STATE OF COLORADO
DEPARTMENT OF TRANSPORTATION
CITY OF COLORADO SPRINGS
Parks, Recreation and Cultural Services Department
CAPITAL IMPROVEMENT PROJECT
TRAIL IMPROVEMENT PROGRAM
COMBINED FEDERAL AID PROJECT No. TAP M240-162, SubAccT. No.20391

STREET IMPROVEMENTS
PLAN of the ROCK ISLAND MULTI-USE TRAIL
SAND CREEK TO CONSTITUTION AVENUE COLORADO
SPRINGS & EL PASO COUNTY, COLORADO
14 March 2024

<p>1604 South 21st Street Colorado Springs, Colorado 80904 (719) 630-7342</p>	Sheet Revisions	90% BID SET	Cover Sheet		Kiowa Proj. No. 16028
		No Revisions:	No Revisions:			
		Revised:	Revised:	Designer: RNW		SubAccT No. 20391
		Void:	Void:	Detailer: RNW		
			Date: 3/14/2024

<p>ROCK ISLAND TRAIL Sand Creek to Constitution Avenue</p>		<p>Kiowa Proj. No. 16028</p>
<p>FINAL TRAIL PLAN STA 77+20 TO STA 82+90</p>		<p>Design: RNW Detail: RNW Date: 3/14/2024</p>		<p>TAP M240-162 SubAcct No. 20391 Sheet Number C113</p>

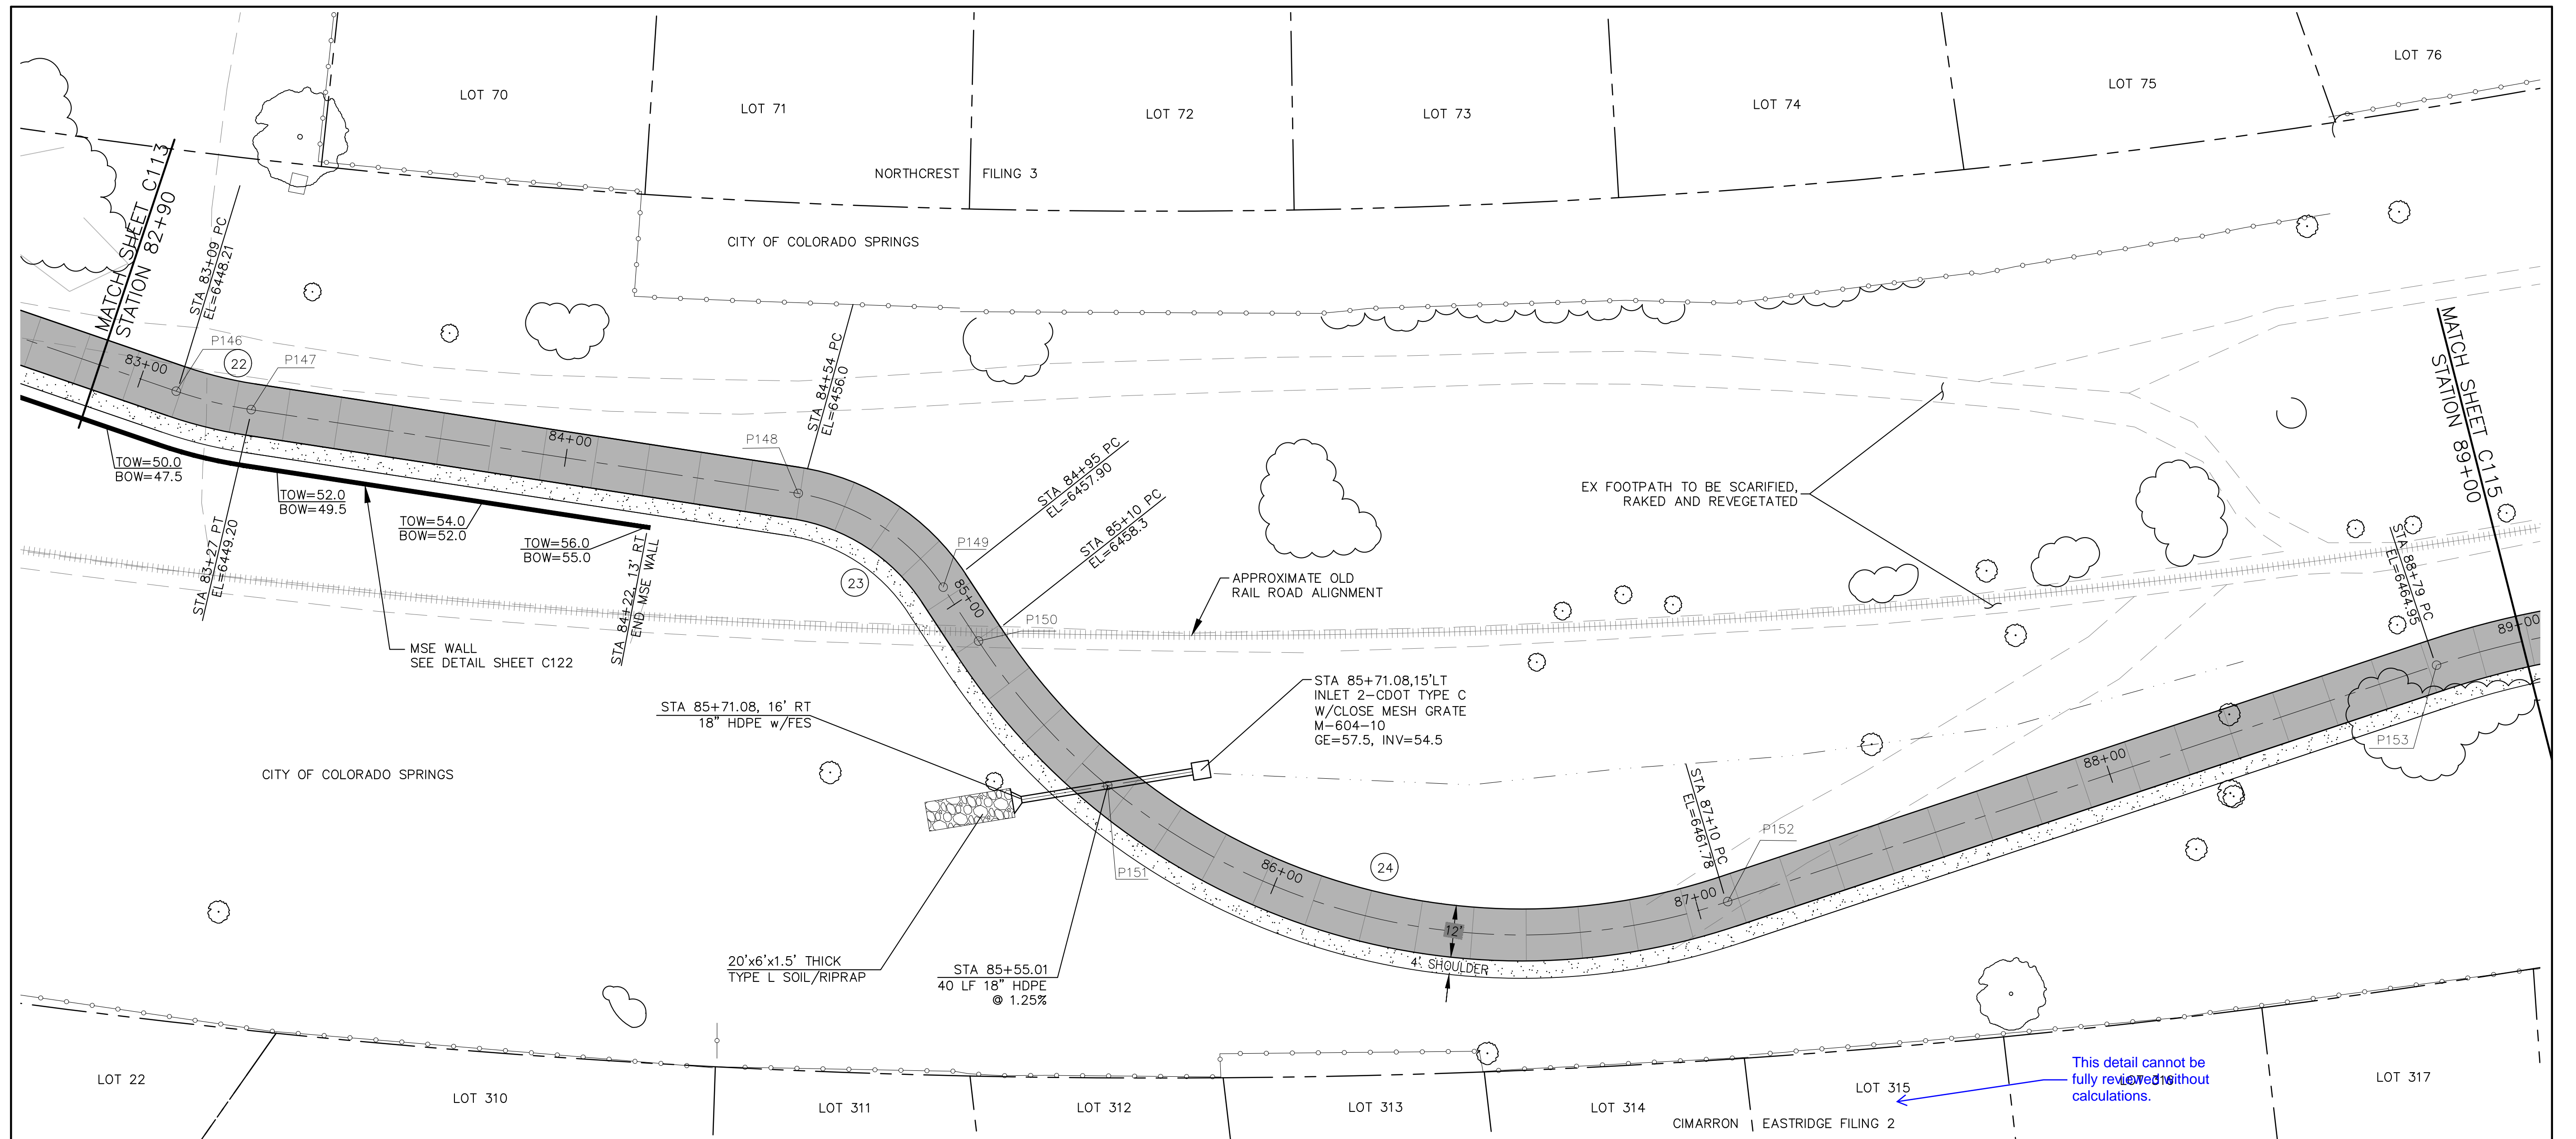
This detail cannot be fully reviewed without calculations.
